**SONOMA COUNTRY
INN**

***Response to Comments on the
Draft Environmental Impact
Report***

COUNTY OF SONOMA
PERMIT AND RESOURCE MANAGEMENT
DEPARTMENT

FEBRUARY 2004

**EXHIBIT 9-5
TREE REMOVAL AREAS**

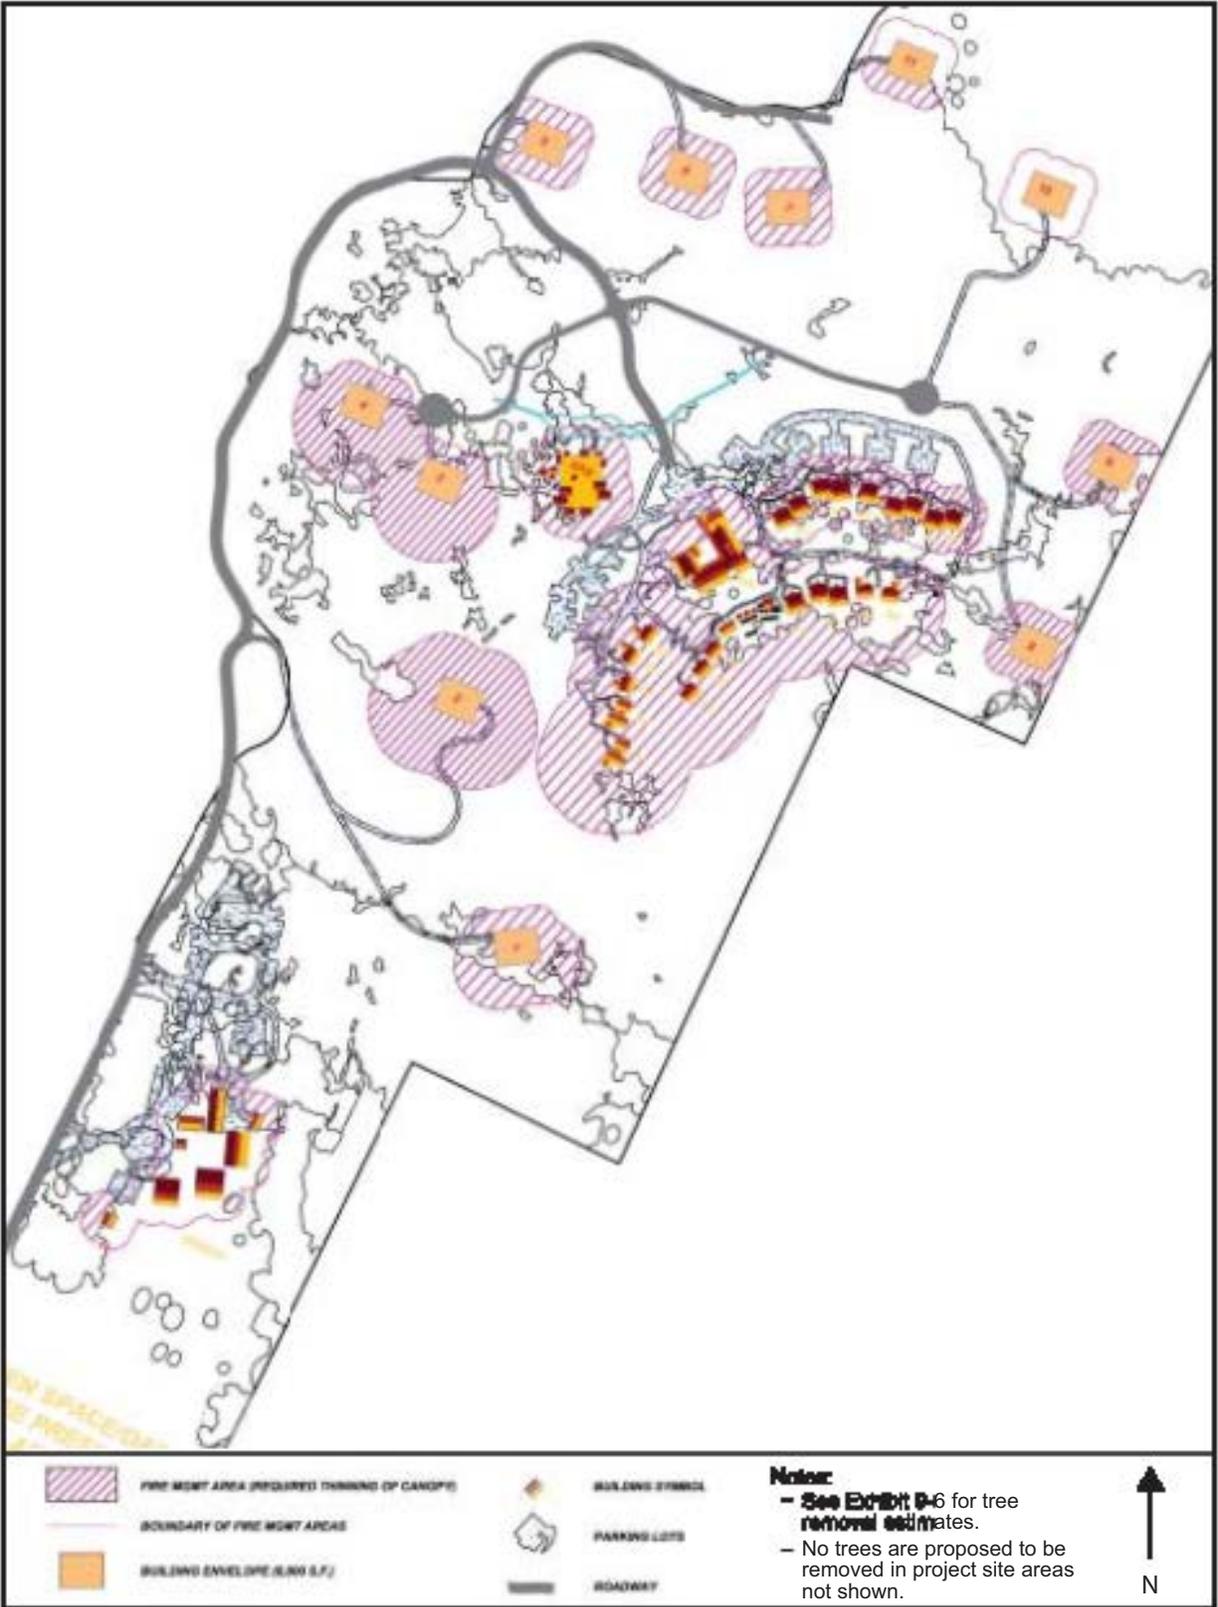
80 In Analysis of Objective OS-1.4 at p. 4.0-11, how did they arrive at the estimate of 3000 trees to be removed? Is that a maximum figure? If not, what is the maximum number to be removed? Without accurate information from the applicant about tree removal, the DEIR's visual impact may very well be even more inaccurate than currently believed. The same questions could be asked about tree removal for residences. Since the applicants deny knowing where the residences and related structures will be located, they cannot provide any meaningful or credible information on the visual impacts. How many trees the owners of the residences post-construction will remove? Will there be any means to effectively assure that additional trees will not be removed.

Exhibit 9-5 shows where tree removal is proposed to occur on the project site. Some adjustments were made in the location of building footprints on residential lots 5, 6, 7, 9, 10, and 11 in response to a combination of factors, including an attempt to avoid the ephemeral drainages that pass through the vicinity of residential lot 7.⁷ However, tree density is relatively uniform across this portion of the site, and the adjusted building footprint locations are not expected to affect total tree removal estimates. Tree removal estimates were tabulated into a condensed form and presented in Exhibit 9-6. Additional information regarding the tree removal estimates is provided in Appendix B. The affected areas where tree removal would occur are identified as:

**EXHIBIT 9-15
INN / SPA / RESTAURANT WASTEWATER DISPOSAL SYSTEM SCHEMATIC REPRESENTATION**

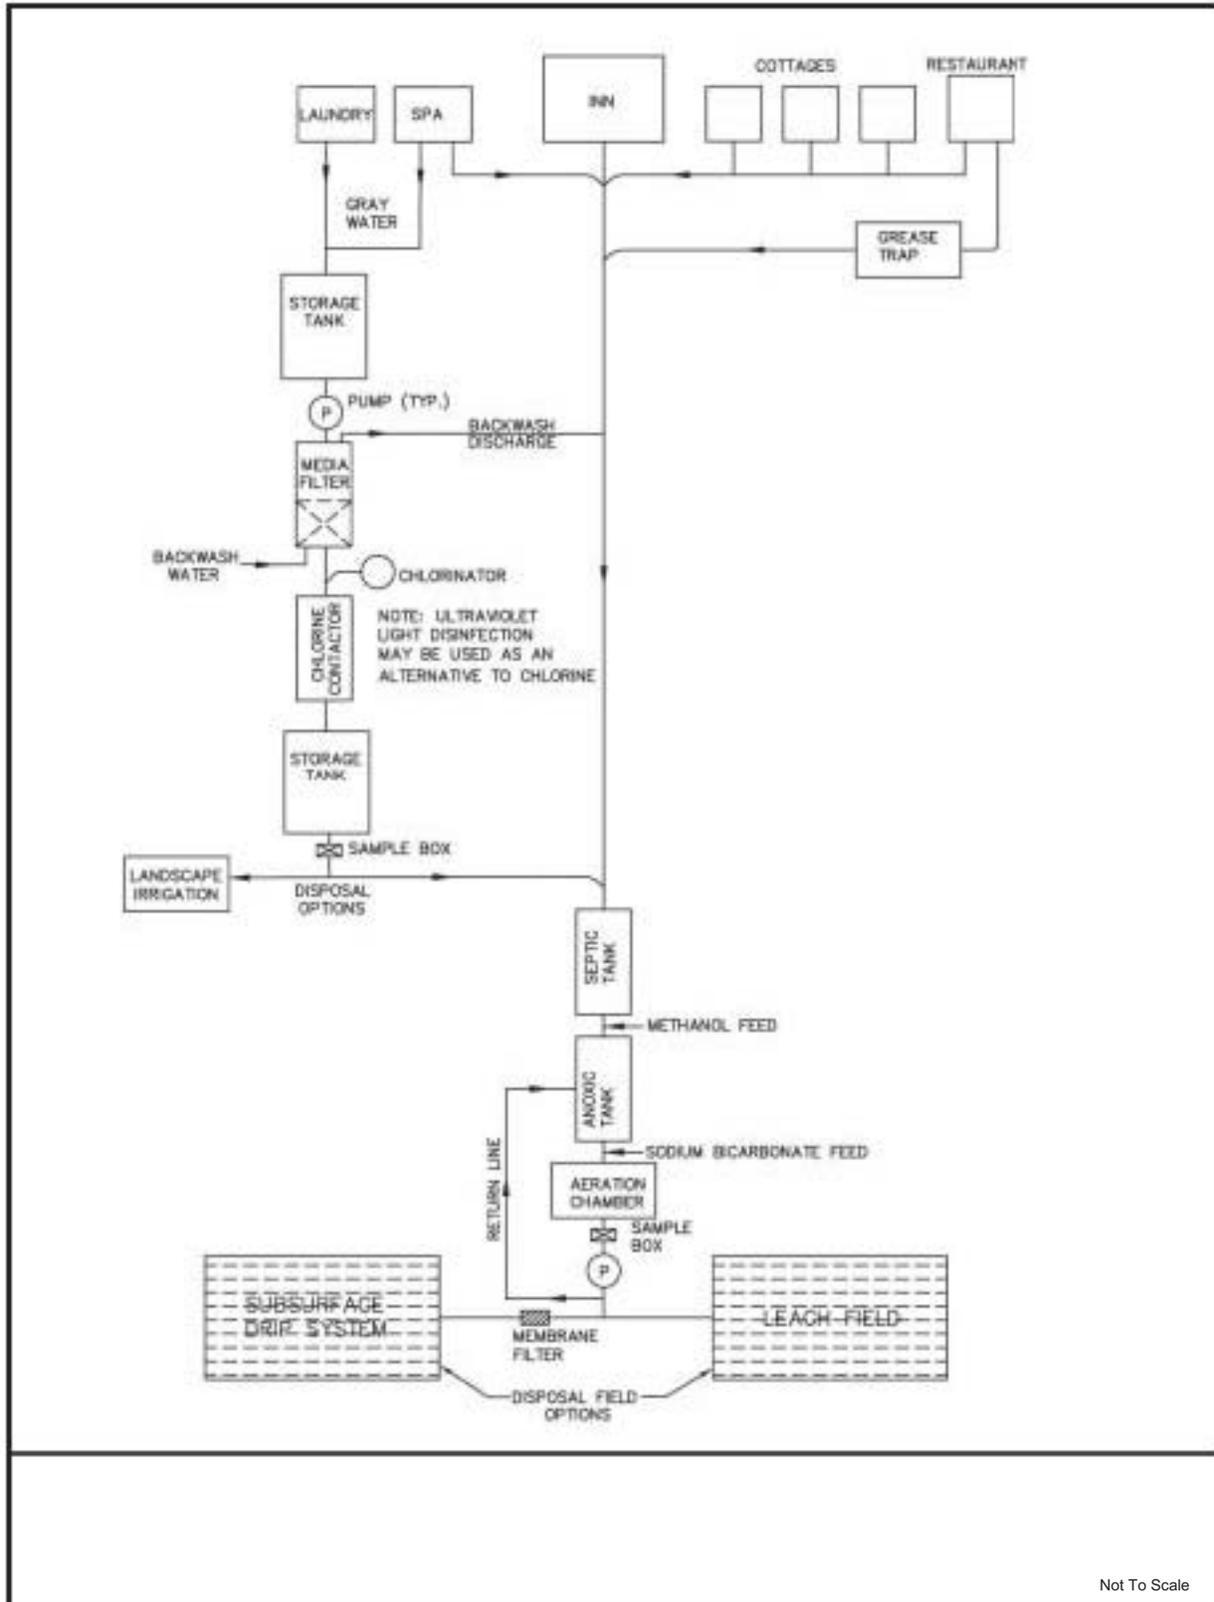
6 (2b) Exhibit 5.4-4 identifies 6400 gallons per day of Spa/Laundry graywater. During dry weather months this water will be used for landscaping irrigation. A wet weather disposal area has not been identified for these flows. If a wet weather use cannot be found for these flows, Exhibit 5.4-3 should be revised to reflect an additional 6400 gallons per day of disposal area within the Inn/Spa/Restaurant leach fields.

In response to comments on the Draft EIR, the applicant has made changes to and clarified the wastewater disposal plan and water use rates, as described in the revised project description. The applicant provided a revised wastewater disposal system schematic diagram for both the inn/spa/restaurant (see Exhibit 9-15) and winery/event pavilion (see Exhibit 9-16) systems. Changes to the inn/spa/restaurant system include:

EXHIBIT 9-16
WINERY / EVENT CENTER WASTEWATER DISPOSAL SYSTEM SCHEMATIC REPRESENTATION

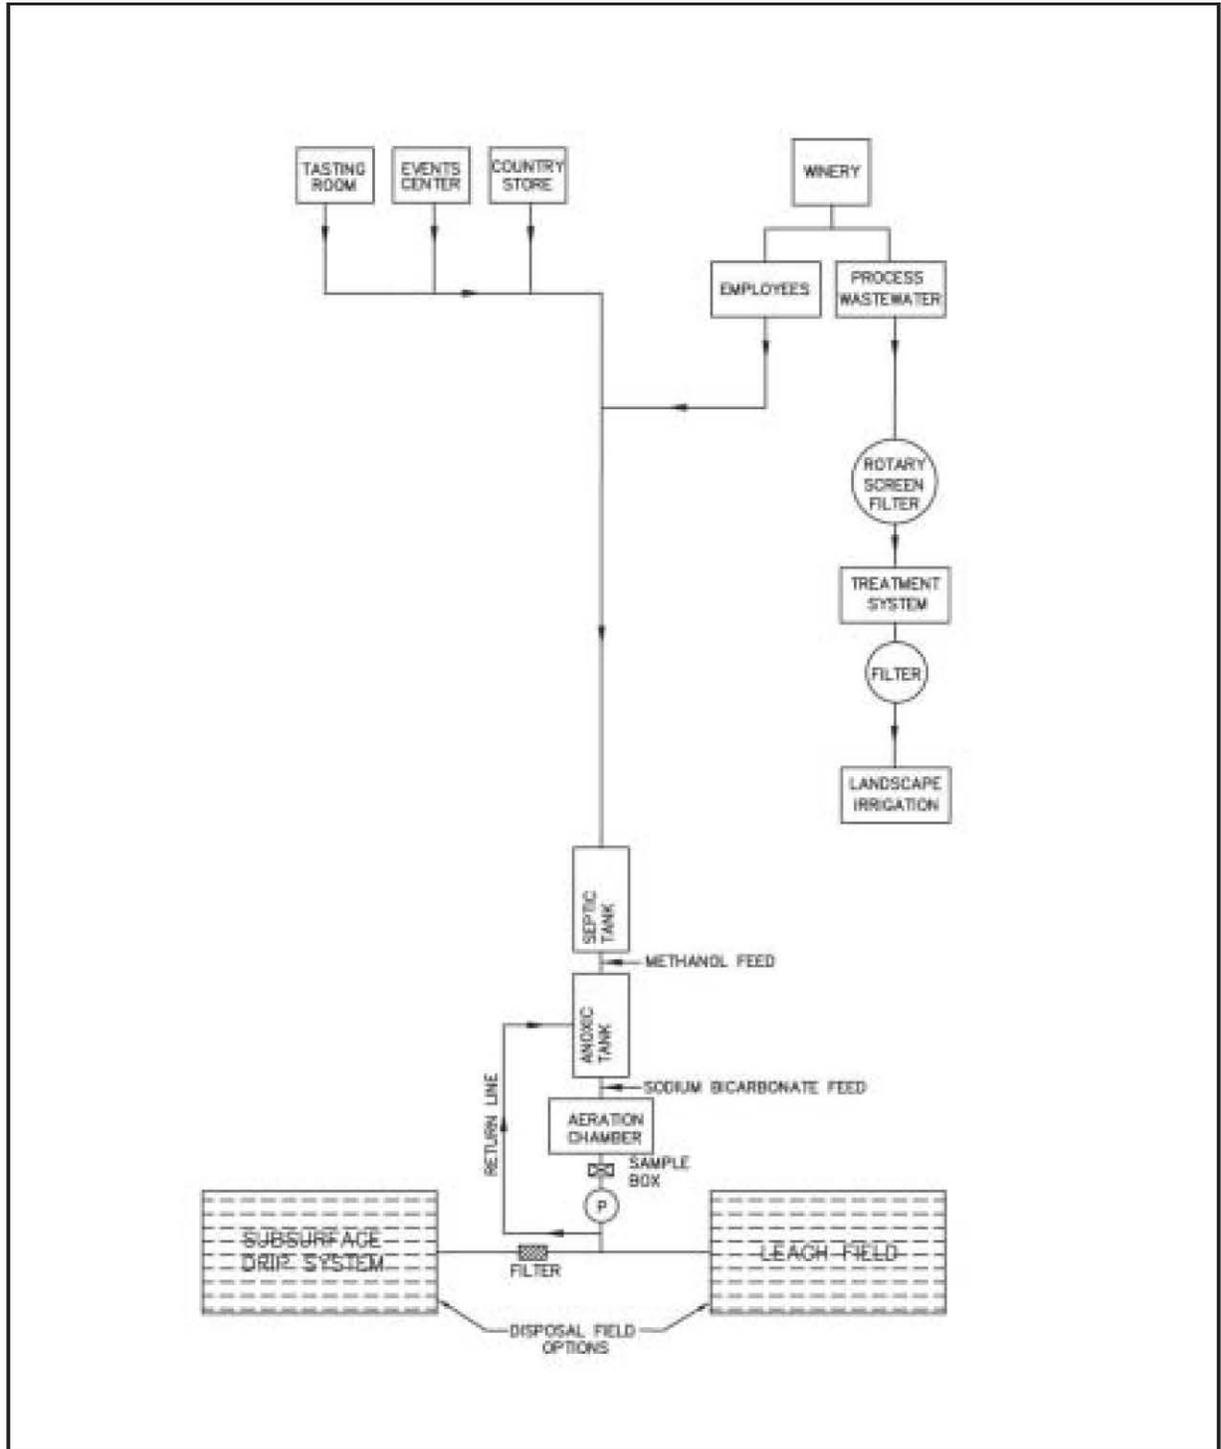
7 (2c) As noted in the DEIR, design wastewater flows for the Winery and Events Pavilion should be revised upwards from 1,955 gpd to 2,810 gpd, in order to conform to Regional Board guidelines. This increase should also be reflected in Exhibit 5.4-3 and Exhibit 5.4-4.

**EXHIBIT 5.5-1
LOCATION OF SPRINGS, EXISTING WELLS, AND NEW WELLS**

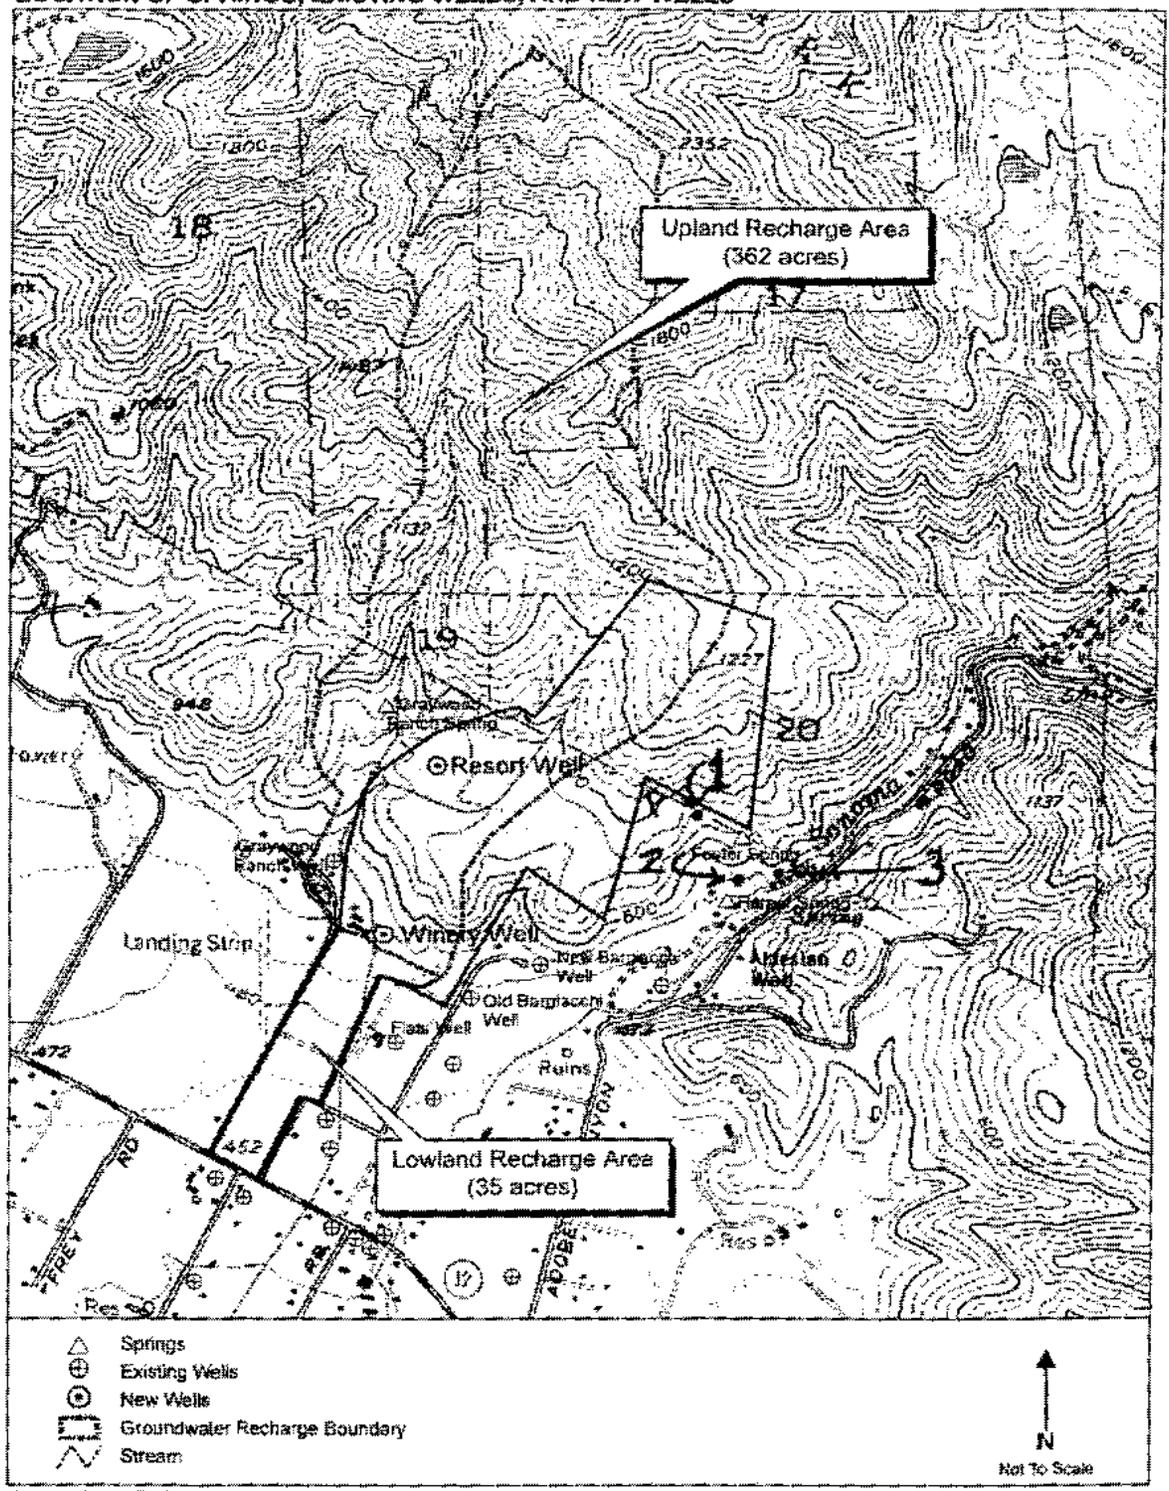
1 Exhibit 5.5-1 (and chapter 5.5) leave out the Baker/Philbin spring, which is of great importance to us. It is, and has been for over thirty years, our only source of household water. The Baker/Philbin spring is closed to the proposed Graywood development and the most likely to be affected. I can't understand why it was not mentioned in the report. This spring, as well as others on the north side of Adobe Canyon, is low flowing and the slightest change in the water table could easily cause it to go dry.

Please see Response to Comment 22-1. The Philbin/Baker spring has been added to Exhibit 5.5-1 and is referenced in the revised text of the EIR. This spring is substantially higher in elevation than the static groundwater level at the Resort Well. Therefore, it receives its water from a higher source, which cannot be influenced by water table conditions at the pumping well.
